# UNITED STATES PATENT AND TRADEMARK OFFICE

| APPLICATION NO.  | FILING DATE | FIRST NAMED INVENTOR | ATTORNEY DOCKET NO.              | CONFIRMATION NO.            |
|--|-------------|----------------------|----------------------------------|-----------------------------|
| 10/776,522   | 02/12/2004  | Yohei Makuta         | 0505-1268P                       | 4129                        |

## Office Action Summary

### **DETAILED ACTION**

**FIG. A**

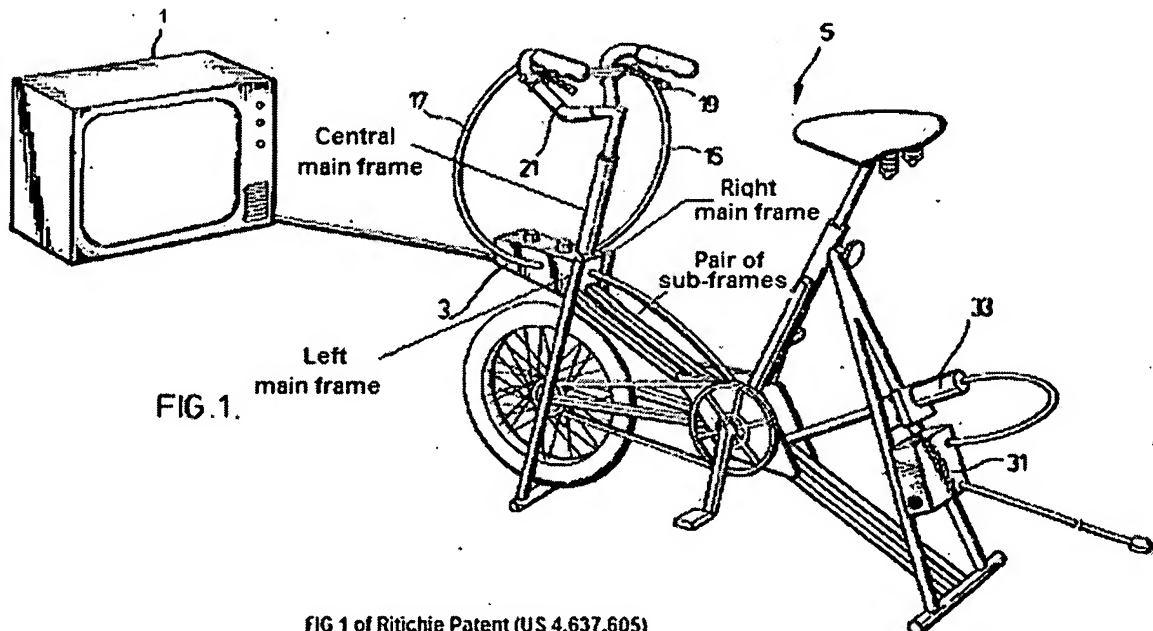
In response to argument (1), Examiner respectfully disagrees. As it can clearly be seen in FIG 1 of Ritchie patent, the control unit (FIG 1, label 3) is placed between the left and right main frames. In addition, there is also a centrally located main frame, the frame on which the central back section of the control unit is attached. See FIG 10 in Appendix 1, to follow the Examiner's interpretation regarding these limitations.

Thus, by comparing the above claimed limitations with FIG A above (FIG 1 of Ritchie's Patent), the Examiner conclude that the body of the simulator of FIG 1 teaches or suggests a pair of left and right main frames and a centrally located main frame for rotatably securing the steering handle mechanism.

# APPENDIX 1.

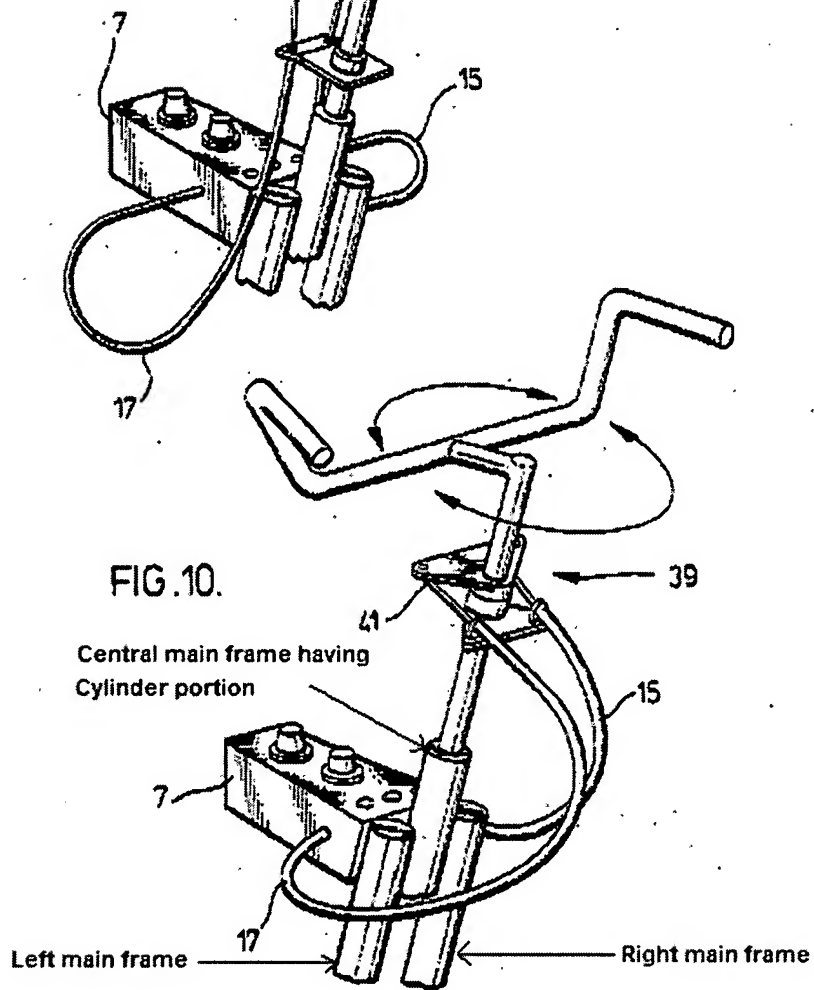
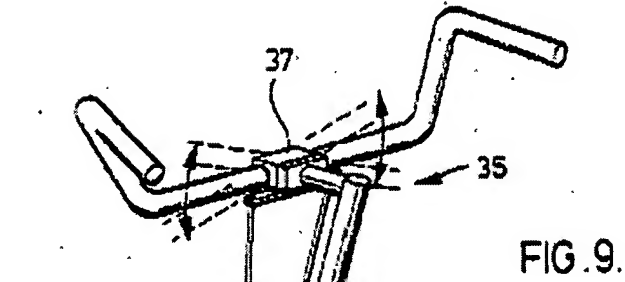
upper end connected to the cylindrical portion (see Appendix 1 below with the examiner's interpretation of FIG 10 of Ritchie's Patent).

With regard to the limitation, *mounting of the control unit under the centrally located main frame*, FIG 10 of Ritchie's Patent properly teaches it. Please, refer FIG 10, on Appendix 1 to follow the Examiner's interpretation.
